7th February 2012

Mirvac
Level 26, 60 Margaret Street
SYDNEY NSW 2000

EXISTING TELECOMMUNICATIONS SERVICES (7 RAILWAY ST, CHATSWOOD)

TELSTRA SYDNEY TO BRISBANE OPTIC FIBRE SERVICE

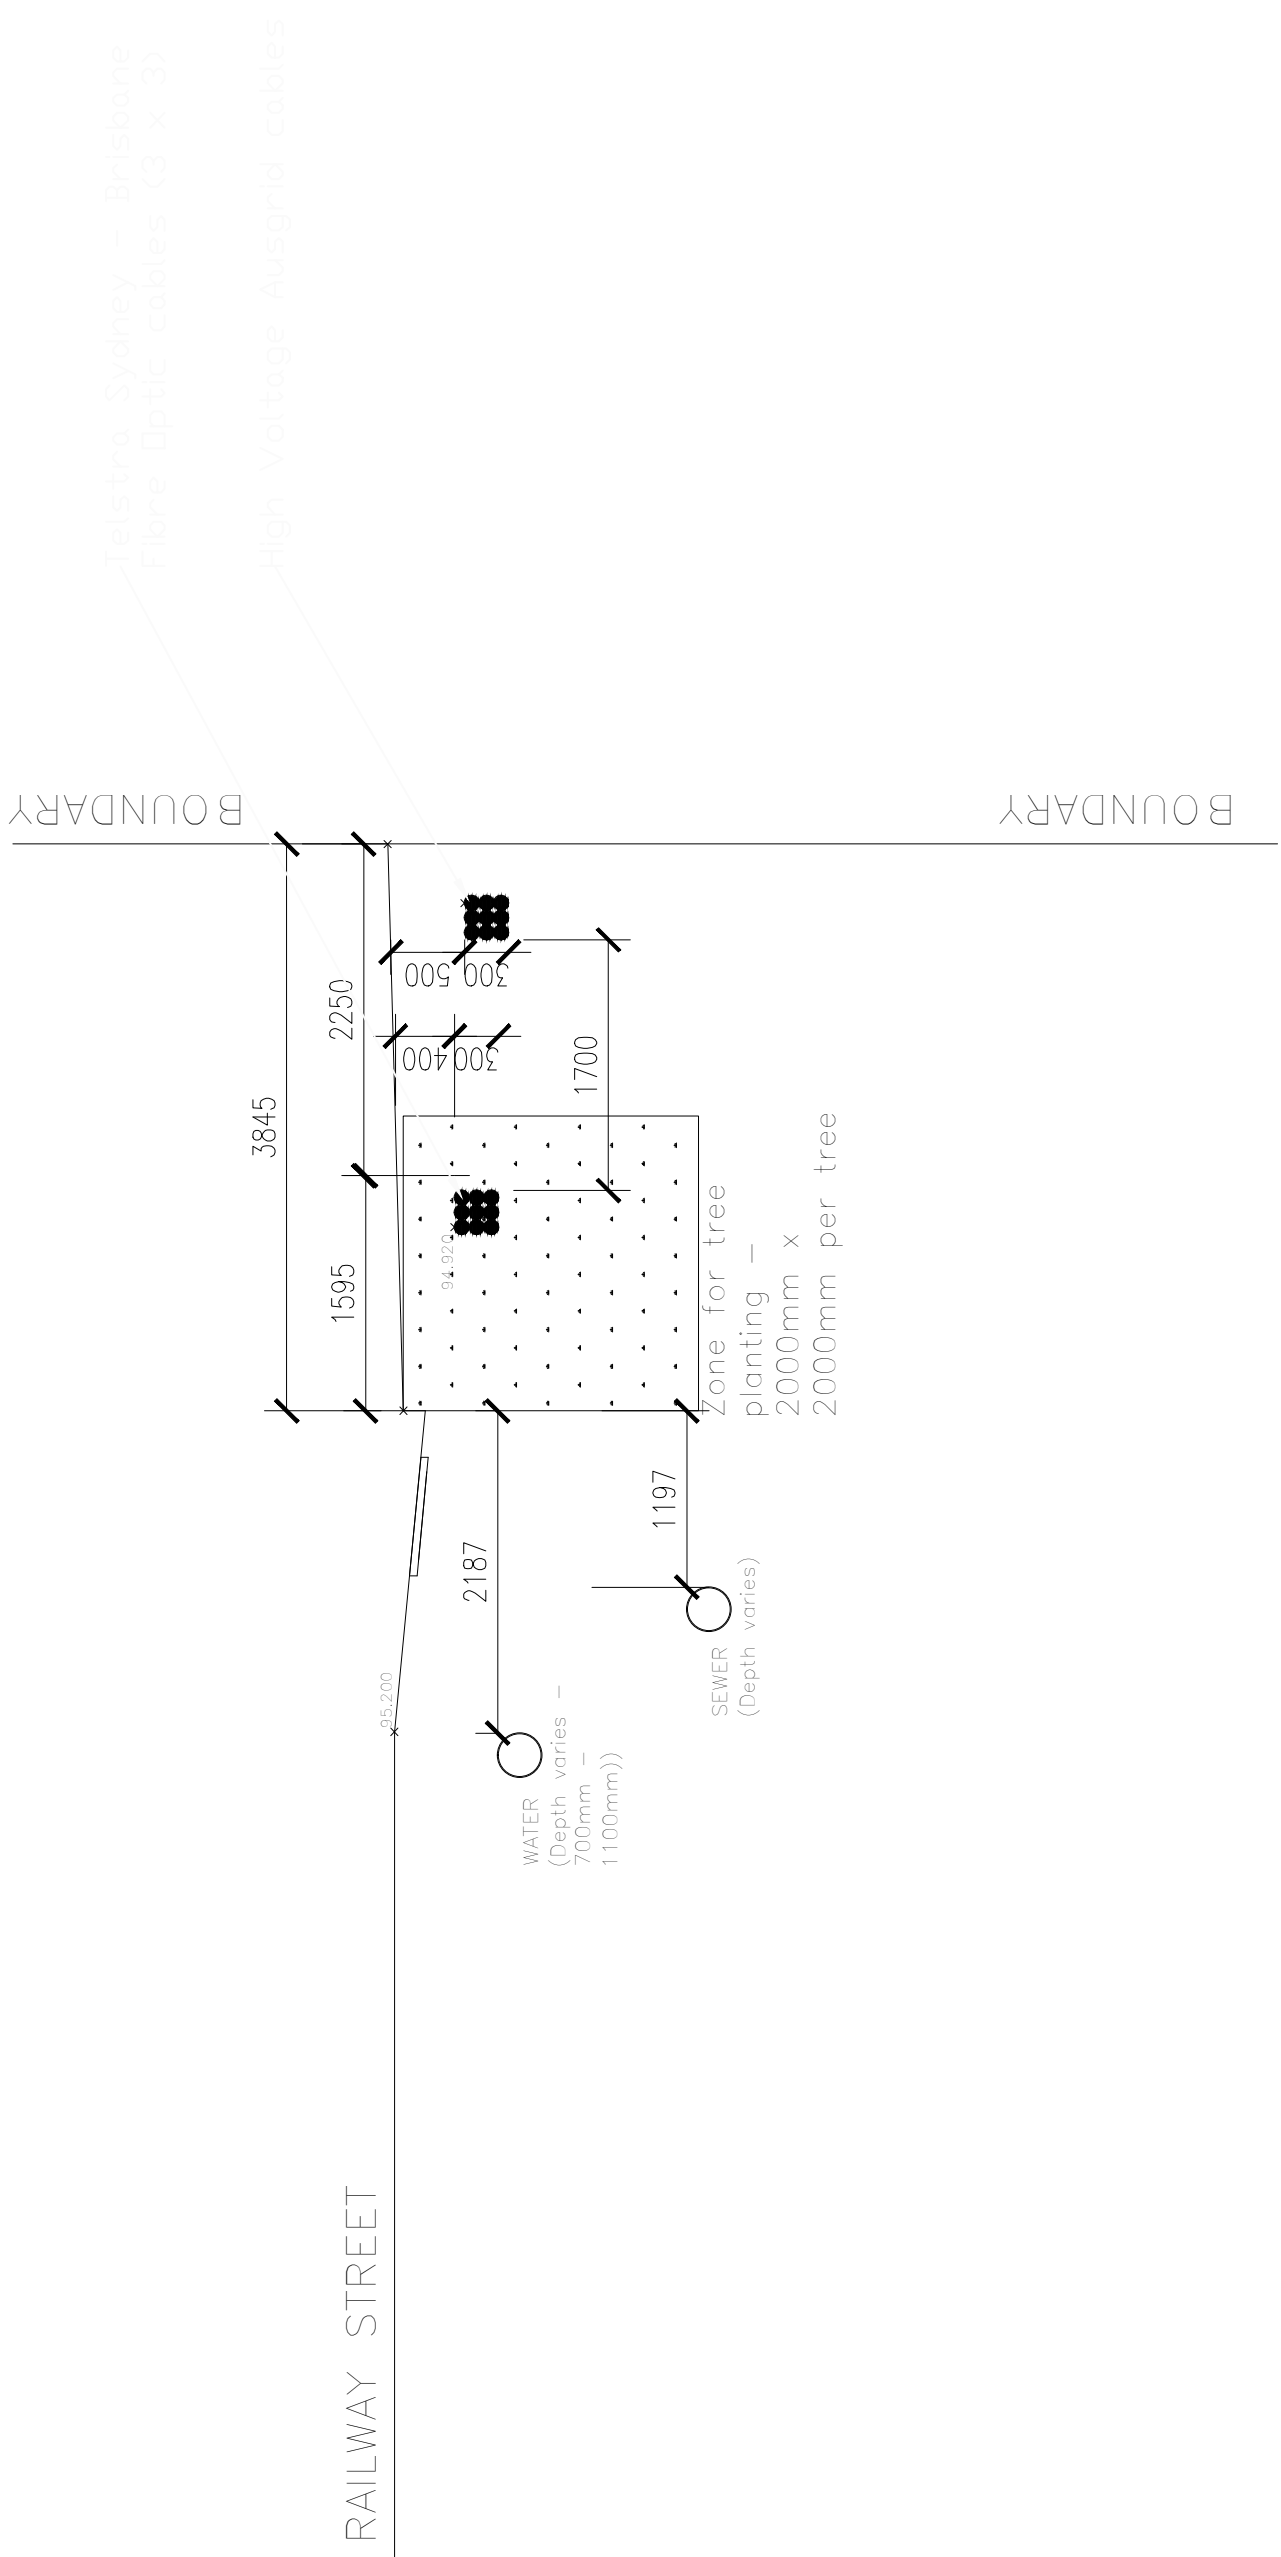
The proposed planter/tree zone on Railway Street will have a major impact on the existing in-ground services, especially on the Telstra underground network.

From our previous work in this area, this Telstra network includes major Sydney-Brisbane fibre links from the nearby Chatswood Telephone Exchange.

The proposed tree zone would require the relocation of the Telstra network including major inter-city fibre links, man-holes and a bank of 9x100mm telecommunications conduits from their standard allocation as determined by the Streets Opening Conference into a compressed shared trench with Ausgrid High Voltage Cabling.

All stakeholders/authorities impacted by the proposed tree planting zone on Railway Street need to be fully consulted prior to proceeding with any works.

TYPICAL SECTION THROUGH RAILWAY STREET

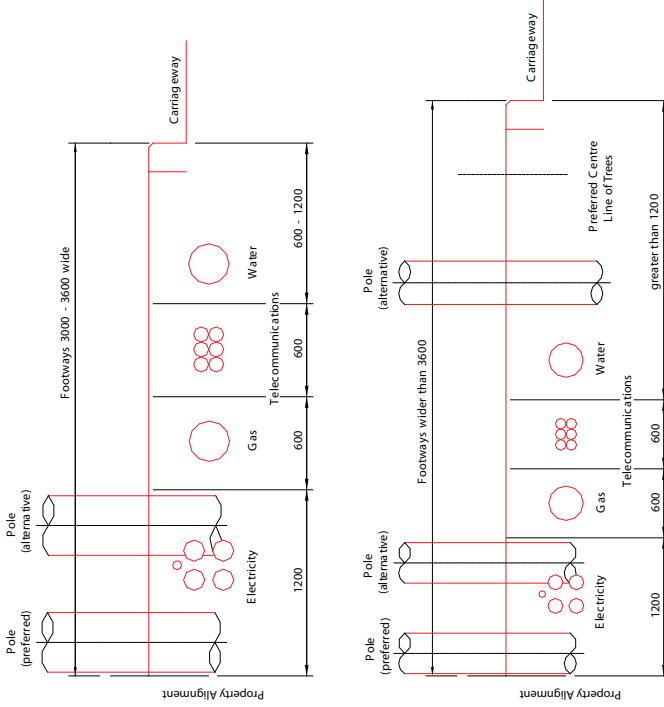
The loss of available verge width for services would leave insufficient space for these major authorities' network services to share a common trench. There are extreme cost penalties for any damage to these major Telstra links due to loss of telecommunication services.
